**PERMIT APPLICATION P35828 - MARIBYRNONG TOWN HALL, 61 NAPIER STREET, FOOTSCRAY (H1218): FURTHER INFORMATION REQUEST**

In response to your letter dated 7 April 2022 seeking additional information in accordance with section 98 of the Heritage Act 2017 I provide the following response and material on behalf of the applicant for heritage permit application P35828. Please note: this letter supersedes the letter dated 5 May 2022 and has been updated to show the location of feature carpet on the first floor.

*Key Plan – Ground Floor general arrangement plan– rooms with statement carpet shaded yellow*

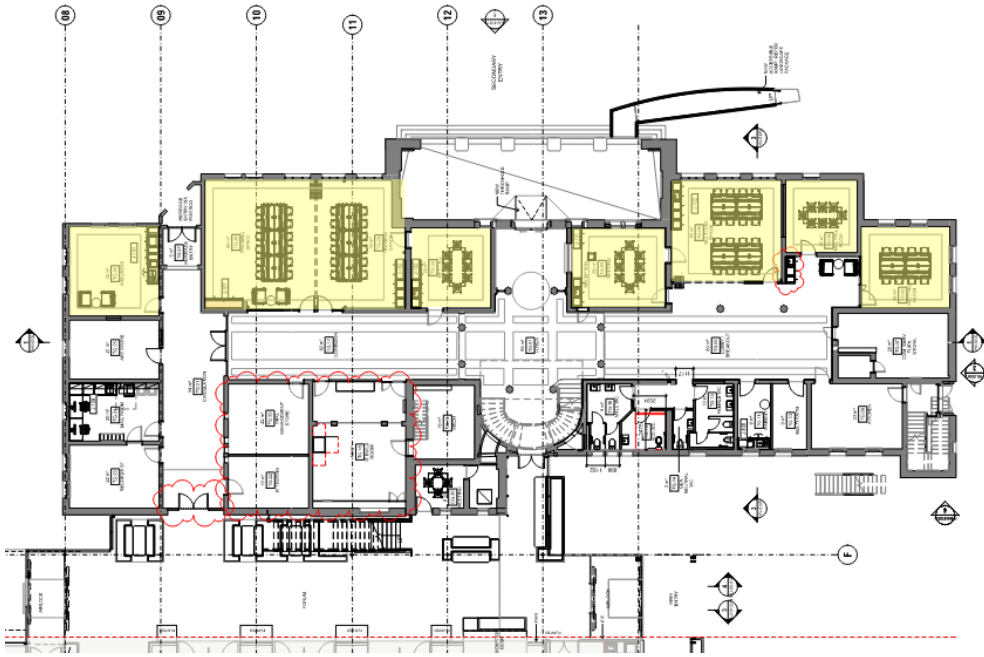
***Photographs showing the rooms in the town hall where 'statement carpet' is proposed.***

The following photographs showing the rooms proposed for 'statement carpet' are provided for your information. This is separated into a key plan and images for the ground floor and for the first floor.
